Memorandum

Subject: Springs at Waterview Preliminary Plan
SP-16-005

This memorandum has been prepared to address the comments you provided concerning the Springs at Waterview Final Plat in your letter dated November 27, 2017. Your comments are provided below with our response comment immediately following in *italics*.

PROJECT: **SPRINGS AT WATERVIEW**
SHEET TITLE: **TITLE SHEET**

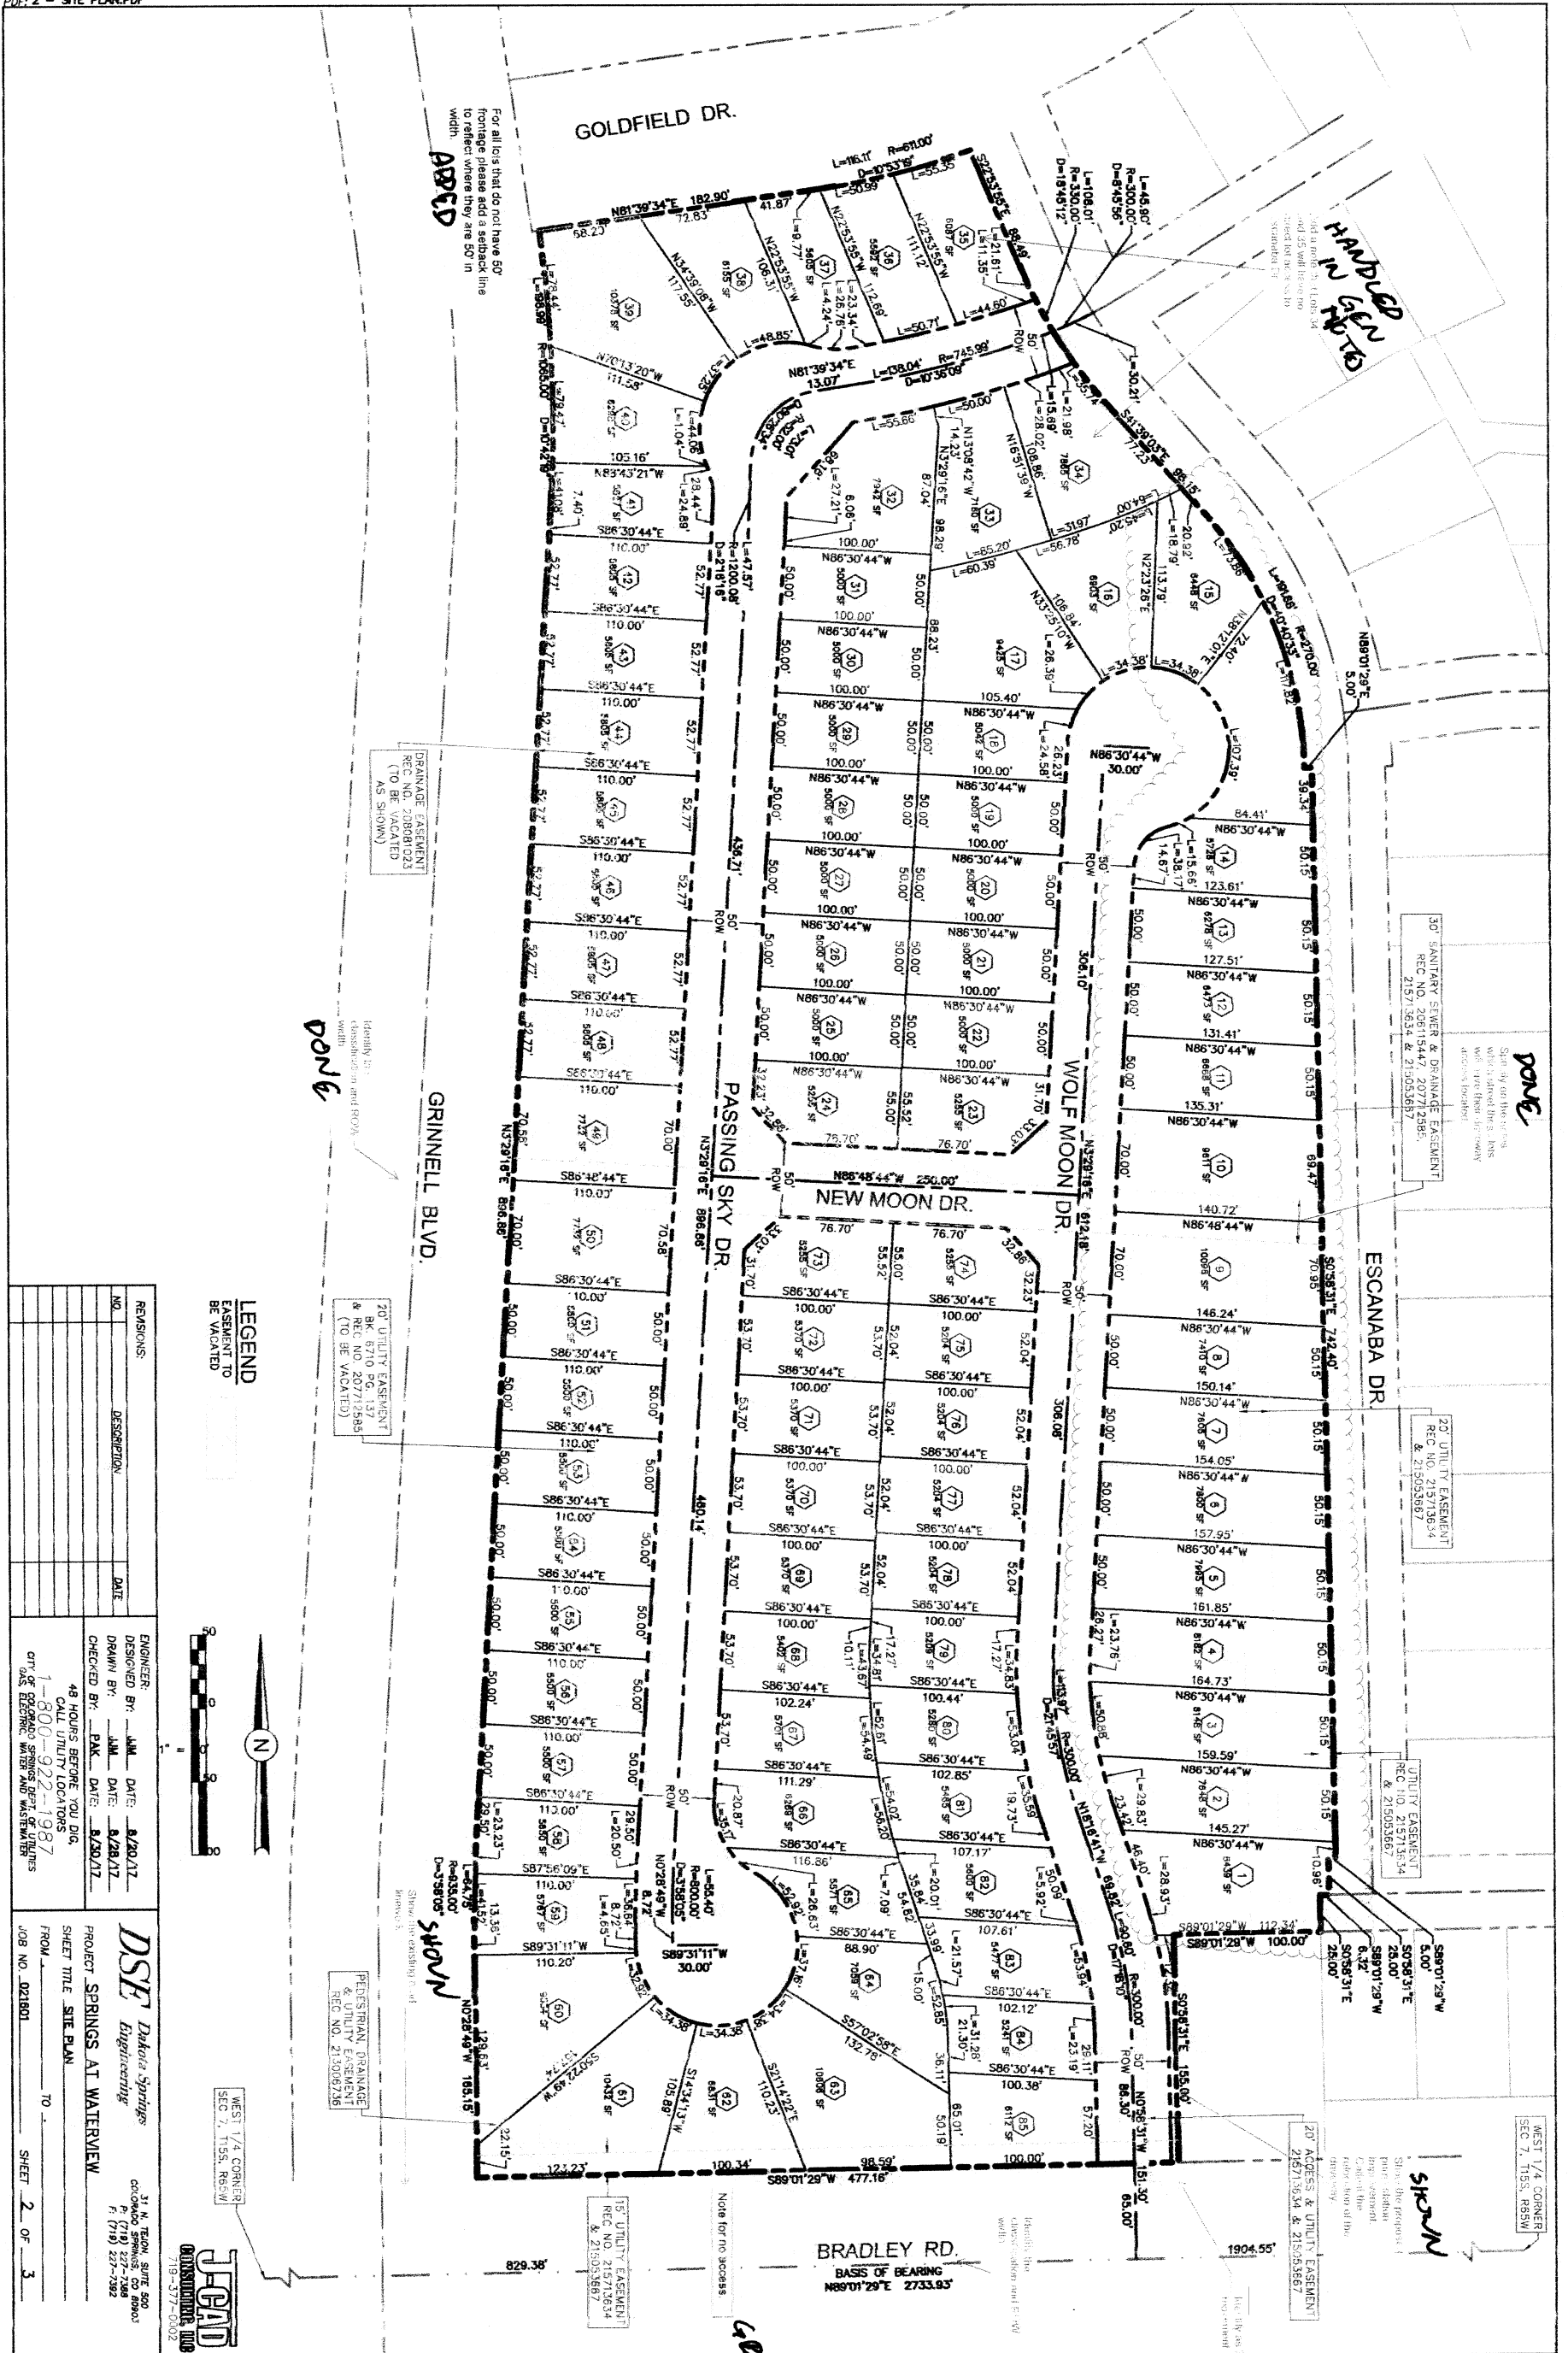
add standard easements
HANDLED IN GEN NOTES
